Z-113
(2016)

PROPOSED SUBDIVISION FOR:
**Habitat for Humanity
 NW Metro Atlanta**

PETITION NO: Z-113
HEARING DATE (PC): 12-06-16
HEARING DATE (BOC): 12-20-16
PRESENT ZONING: R-20

APPLICANT: Habitat for Humanity of Northwest Metro Atlanta, Inc. **PETITION NO.:** Z-113

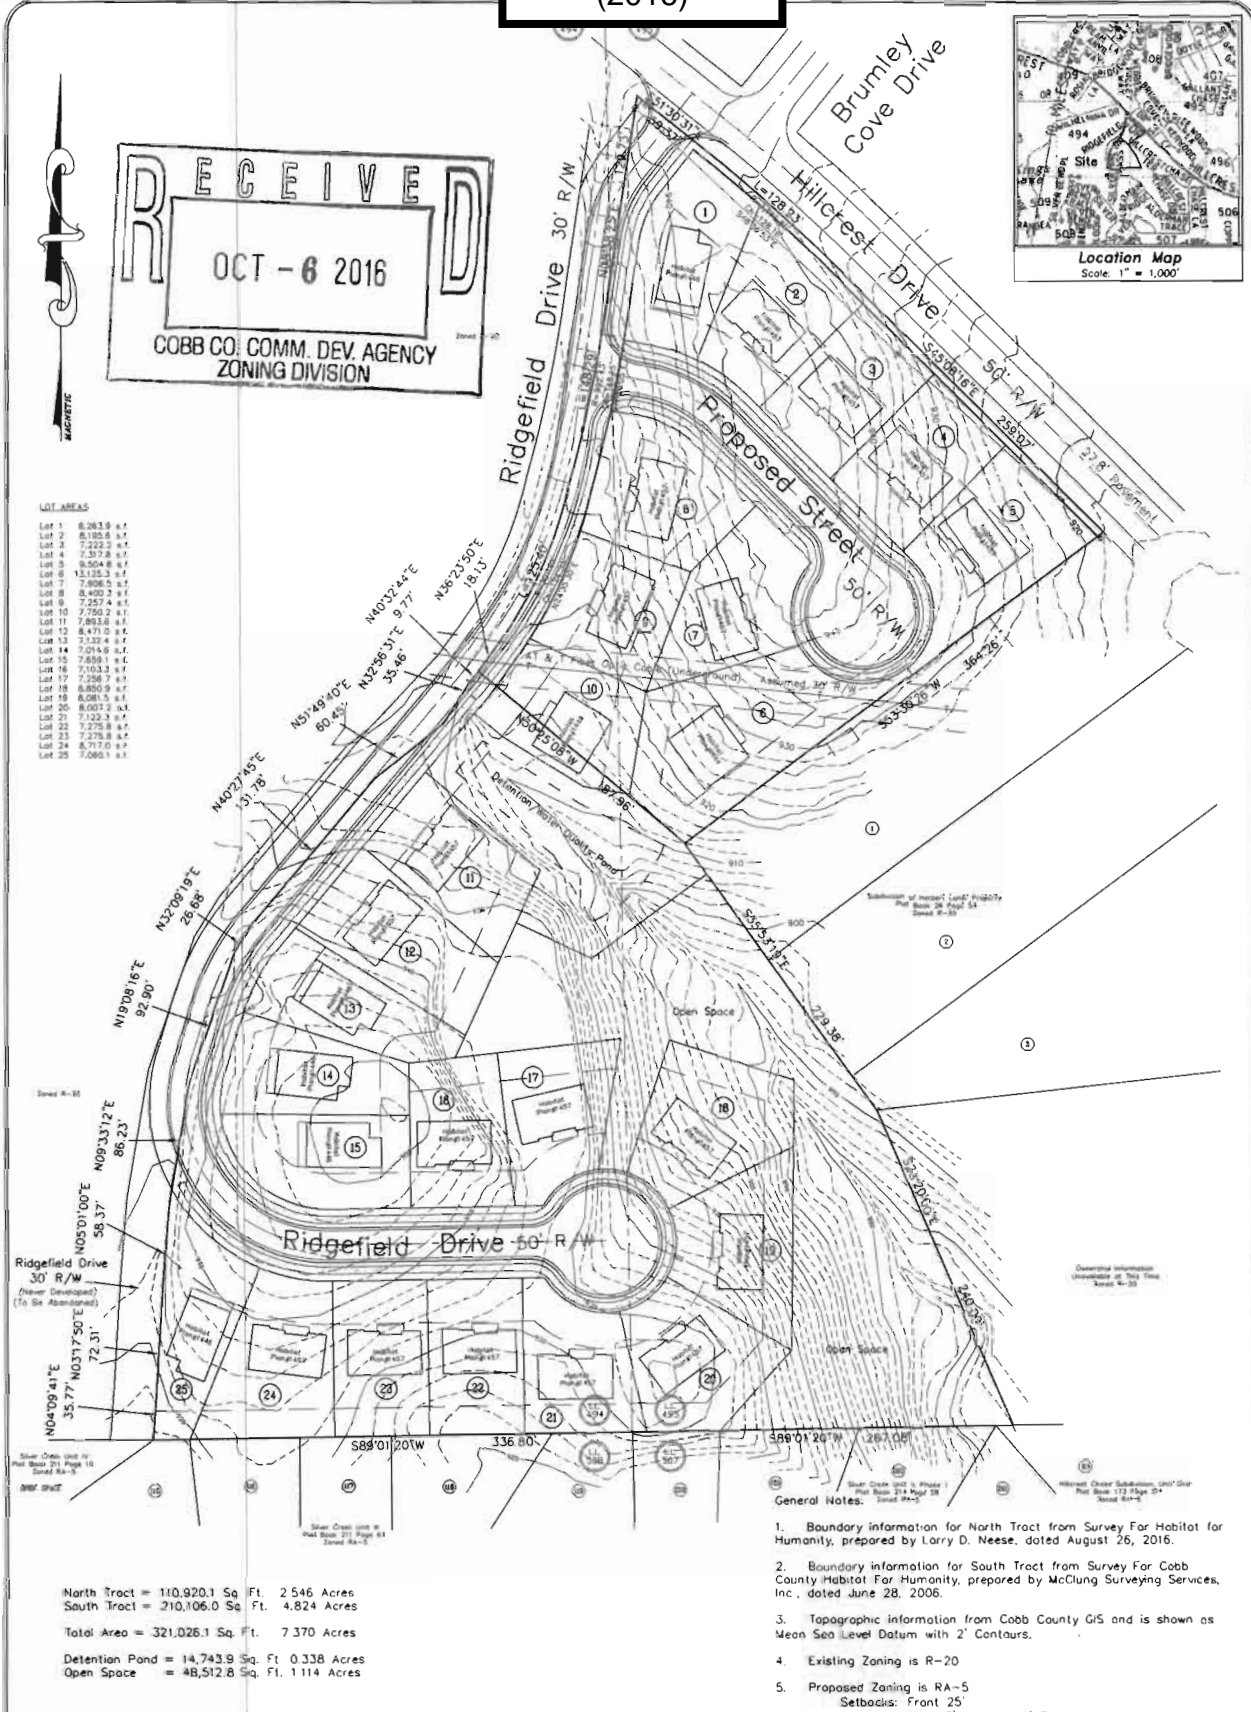
The proposed site plan will require a contemporaneous variance to waive the rear setback from the required 40 feet to 20 feet (the lots along Hillcrest Drive will continue to have a 40-foot rear setback).

GUEST PARKING: When projects contemplate less than 20 foot separation between units, guest parking shall be provided at a ratio of one-half space for each dwelling unit (1 space/2 units).

Developer may be required to install/upgrade water mains, based on fire flow test results or Fire Department Code. This will be resolved in the Plan Review Process.

Additional Sewer easement likely required to serve southern lots. Northern lots may be served via
Comments: Hillcrest Drive, depending on final elevations

- Provide comprehensive hydrology/stormwater controls to include development of out parcels.
- Submit all proposed site improvements to Plan Review.
- Any **spring activity** uncovered must be addressed by a qualified geotechnical engineer (PE).
- Structural fill _____ must be placed under the direction of a qualified registered Georgia geotechnical engineer (PE).
- Existing facility.
- Project must comply with the Water Quality requirements of the CWA-NPDES-NPS Permit and County Water Quality Ordinance.
- Water Quality/Quantity contributions of the existing lake/pond on site must be continued as baseline conditions into proposed project.
- Calculate and provide % impervious of project site.
- Revisit design; reduce pavement area to reduce runoff and pollution.

- No Stormwater controls shown _____
- Copy of survey is not current – Additional comments may be forthcoming when current site conditions are exposed.
- No site improvements showing on exhibit.

1. This site is located just south of Hillcrest Drive and east of Ridgefield Drive. The site is wooded with slopes ranging from approximately 5% near the ridgelines to 50% within the ravine that runs through the center of the site. The stream that traverses the site is identified on the County’s Stream Buffer Map as having a 50-foot undisturbed buffer. This will need to be verified since it will dictate the location of the proposed stormwater management facility. It will also impact the viability of lots 10, 11 & 18.

Hillcrest Drive is classified as a major collector and according to the available information the existing right-of-way does not meet the minimum requirements for this classification.

Ridgefield Drive is classified as a local and according to the available information the existing right-of-way does not meet the minimum requirements for this classification.

Recommend curb and gutter along both sides and sidewalk along one side of proposed development roadway.

Recommend curb, gutter, and sidewalk along the frontage of Ridgefield Drive and Hillcrest Drive.

Ridgefield Drive is a substandard street. Recommend improving Ridgefield Drive from along the frontage to the intersection with Hillcrest Drive to comply with Cobb County Standards.

Recommend a no access easement along the Hillcrest Drive frontage.

Recommend development street either directly align or have an offset of a minimum of 125 feet from Brumley Cove Drive per Development Standard 401.10.

1. Site plan received by the Zoning Division on October 6, 2016, with the District Commissioner approving minor modifications;
2. Variance mentioned in the Zoning Comments section;
3. Fire Department comments and recommendations;
4. Water and Sewer Division comments and recommendations;
5. Stormwater Management Division comments and recommendations;
6. Department of Transportation comments and recommendations; and
7. Owner/developer to enter into a Development Agreement pursuant to O.C.G.A. §36-71-13 for dedication of system improvements to mitigate traffic concerns.
